RADIATION SAFETY OFFICE

Re: Control No. 86717

This letter responds to your May 11, 1977 inquiry regarding the Co-60 Teletherapy Facility, (Presbyterian-University Hospital, License Number 37-00245-05) survey results.

Figure #1  
Scale 1/20 Full size

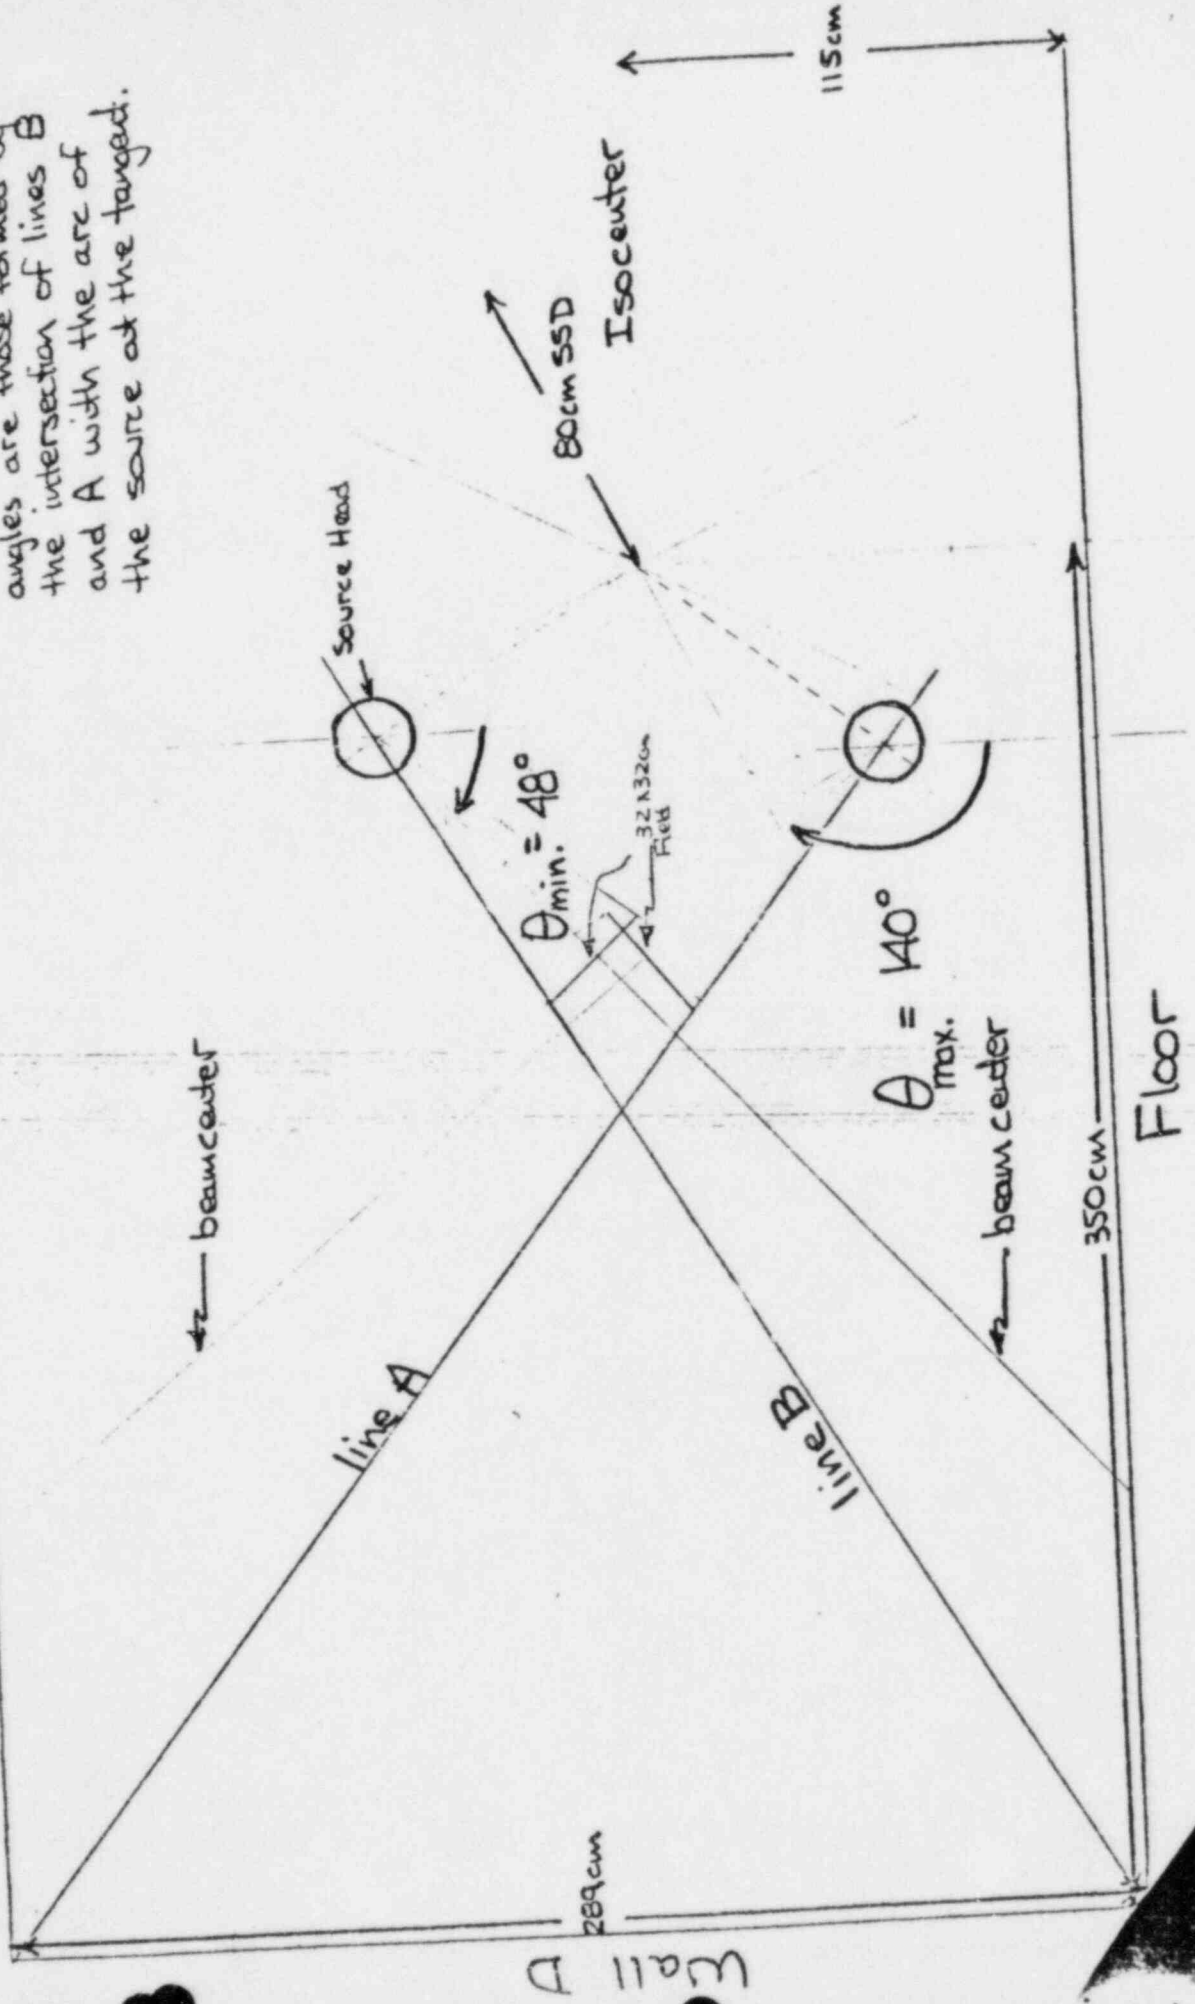
4. a. The unattenuated beam can be directed towards Wall B, the ceiling and the floor but not towards any portion of Wall D, due to a recently installed micro-mercury switch assembly that eletrically limits the unattenuated primary beam use. There are no other electrical or mechanical stops employed to serve this same purpose.

Since the beam limiting mercury switches allow the source to operate independent of the gantry rotation angle, a set of minimum angles from the vertical can be specified for the source head rotation. This will define the area of Wall D from the floor to the ceiling in terms of an angle from the vertical which can be readout directly on the source head housing. Referring to Figure #1 as attached, the maximum angle from the downward vertical position will be defined by the angle  $\theta_{\max} = 140$  degrees and the minimum angle  $\theta_{\min} = 48$  degrees. At any head rotation from  $\theta_{\max}$  through and including  $\theta_{\min}$ , the source is electrically inoperable, therefore incapable of striking any portion of Wall D with the unattenuated primary beam. This is for a maximum field size of 32 x 32 cm at 80 cm SSD.

minimum and maximum limiting angles are those formed by the intersection of lines B and A with the arc of the source at the target.

Figure #2

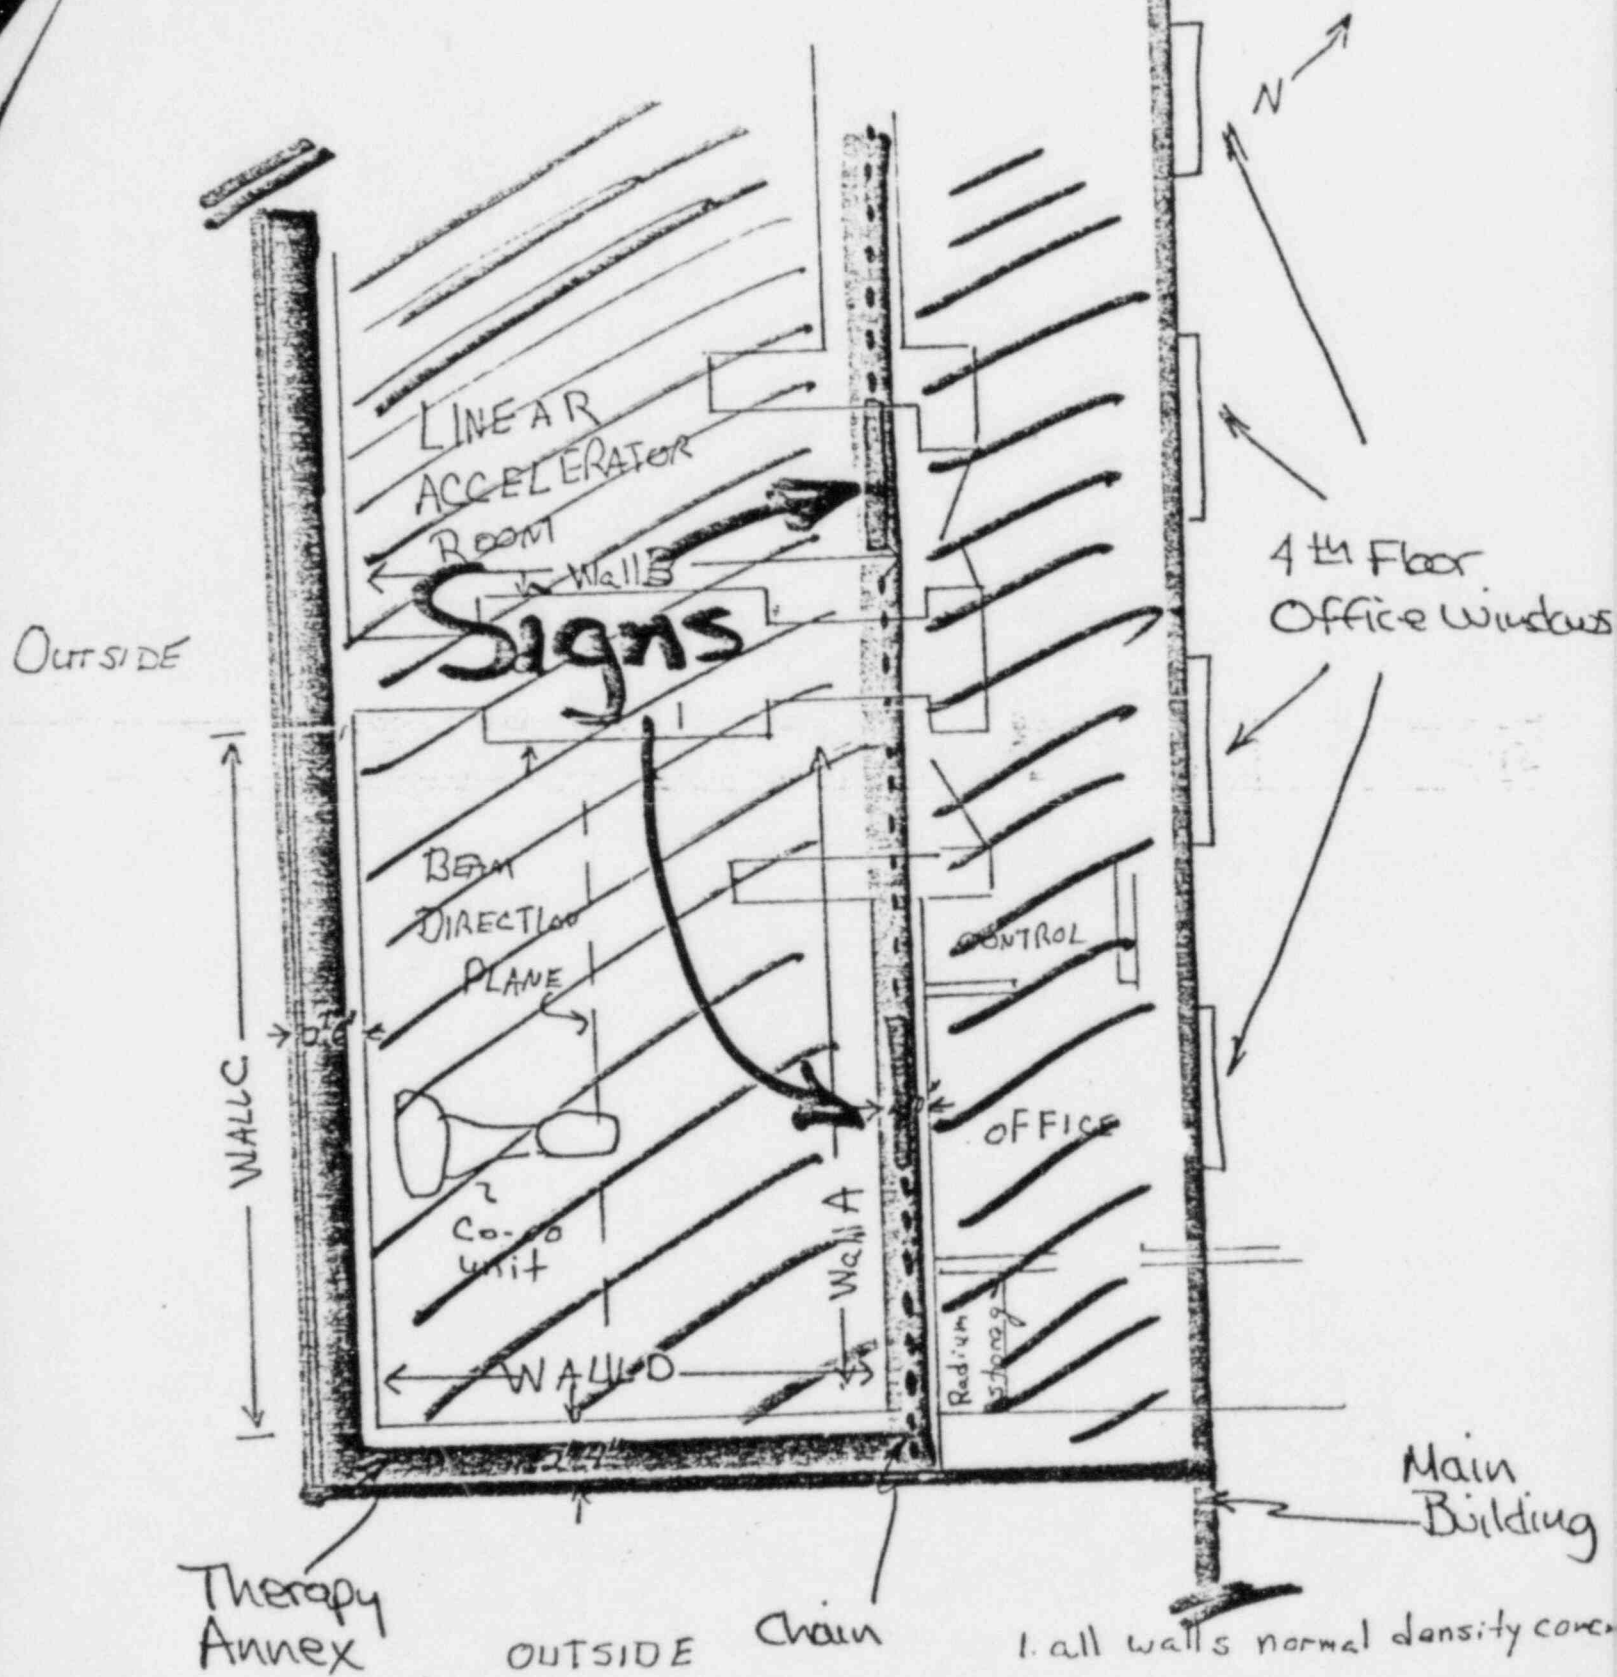
5. The roof of the Co-60 Teletherapy Room is now posted as a radiation area.
  - a. The controls used to restrict access to this area are primarily administrative, in nature. The area has been posted as a radiation area at the point of typical access to the annex roof (see Figures 2 & 3). The signs are conspicuously posted and are visible to persons who try to gain access to this roof from (1) an adjoining roof of the main building and (2) by use of a ladder from the loading dock level. Typical access to this roof is through the use of keyed windows on the 4th floor of the main building, allowing access to the previously mentioned adjoining roof.

- b. Four 8" x 10" metal signs have been posted on the annex building roof (see Figures 2 & 3) they are placed two (2) back-to-back and each carries the words "Caution - Radiation Area - Contact the Radiation Safety Office before entering this roof area 624-2728".
